Work Order ID 92847

Item Name: Crosstube Fwd High

DART AEROSPACE LTD		Work Order:	92847
Description: Crosstube High Fwd (205/212/412)		Part Number:	D212-664-101
Inspection Dwg: D212-664-141	Rev: D	Page 1 of 1

DRAWING NO. D212-664-141	TITLE XTUBE ASSY (205/212/412 HI FWD)	REV. D	DART AEROSPACE LTD ENGINEERING ORDER		D.E.O. NO. D212-664-141-D-1	SHEET NO. SHEET 1 OF 2	SCALE NTS
DRAWN	CHECKED	MFG. APPR.	APPROVED	DE APPR.			
DATE 11.04.07	DATE 11.07.11	DATE 11.04.12	DATE 11/04/12	DATE 11.04.12

**D212-664-141/-141B
ASSEMBLY DETAIL**

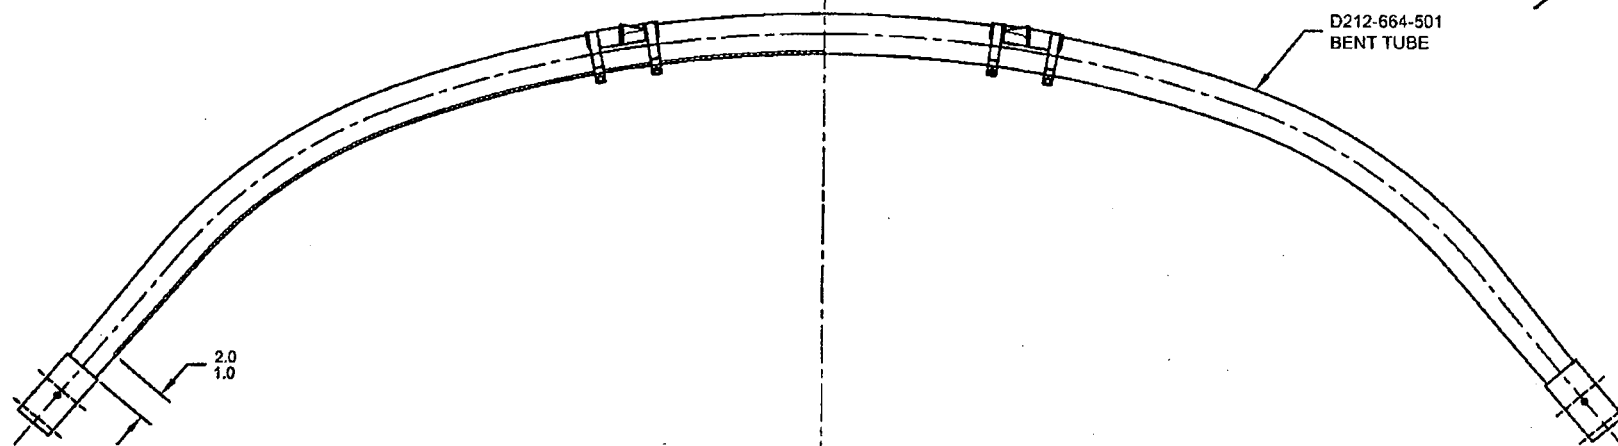
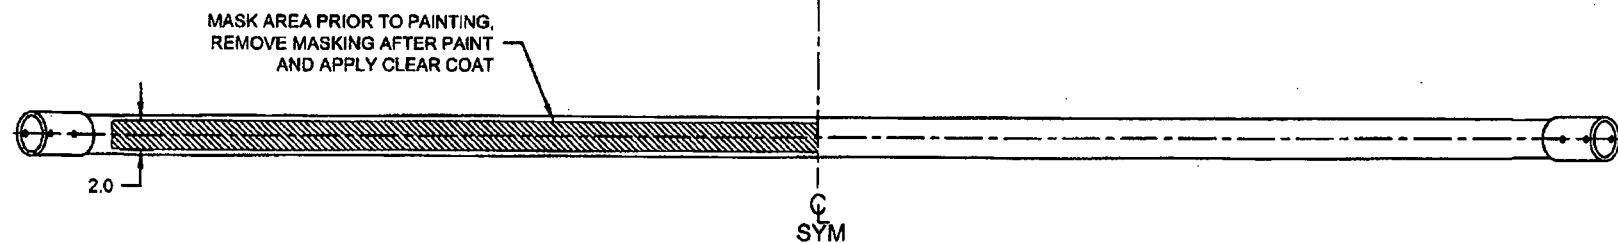
PURPOSE:

ADD AN INSPECTION WINDOW TO UNDERSIDE OF CROSSTUBE.

NOTES 2 OF SHEET 1 IS AMENDED AS FOLLOWS:

- 2) FINISH: CHEMICAL CONVERSION COAT PER DART QSI 005 4.1
PRIME INSIDE AND OUTSIDE PER DART QSI 005 4.2
MASK UNDERSIDE OF CROSSTUBE AS SHOWN (HATCHED AREA) AND
PAINT OUTSIDE PER DART QSI 005 4.2
REMOVE MASKING AND APPLY CLEAR COAT

- 2) FINISH: CHEMICAL CONVERSION COAT PER DART QSI 005 4.1
PRIME INSIDE AND OUTSIDE PER DART QSI 005 4.2
PAINT OUTSIDE PER DART QSI 005 4.2
